To: Auburn Planning Board
 From: Megan Norwood, City Planner
 Re: Site Plan/Special Exception: Construction of a 5,100 Square Foot Building Addition and Parking Expansion for a Total of 139 Parking Spaces at the 76 Merrow Road Western Maine Transportation Services Building, (PID: 178-017)
 Date: May 11, 2021

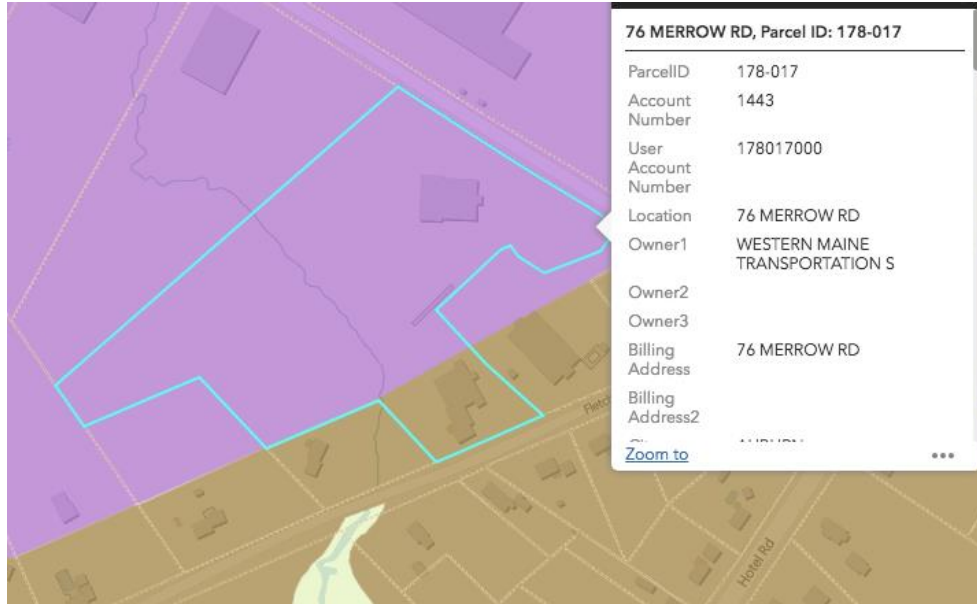
It is important to note that the plan being reviewed by the Planning Board at this time has evolved from discussions over several years that started with parking proposed almost entirely within the Industrial District. The Zoning Map below shows how this parcel is split between the Industrial and Residential districts. The original parking configuration in the Industrial District would have the parking in the backyard of the Wall property and Toodle Inn. Staff recommended reviewing the plans with the neighboring properties to identify a solution that would provide adequate buffering and reduce any potential impacts from the vehicles.
